REQUEST FOR INFORMATION **DATE:** May 16, 2016 **NO.:** RFI-086

Project Name: Webster University Interdisciplinary Science Building Project No.: 15051

Subject: Stud wall at room 185

Room 185 Spill Closet

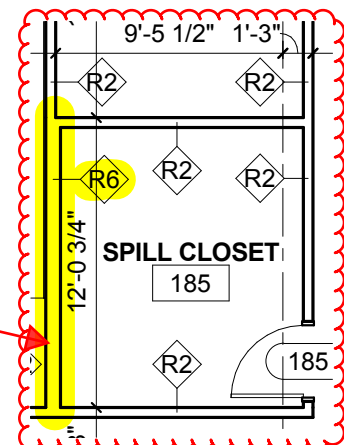
Plumbing drawing calls for a 3" sanitary line to drop down in the West wall of 185 Spill Closet. This is a 3-5/8" stud and is too small for a 3" sanitary pipe. See attached.

Solution: Increase stud wall to 6".

Revise the west wall of '185 SPILL CLOSET' room to type 'R6' with 6" stud. See sketch.
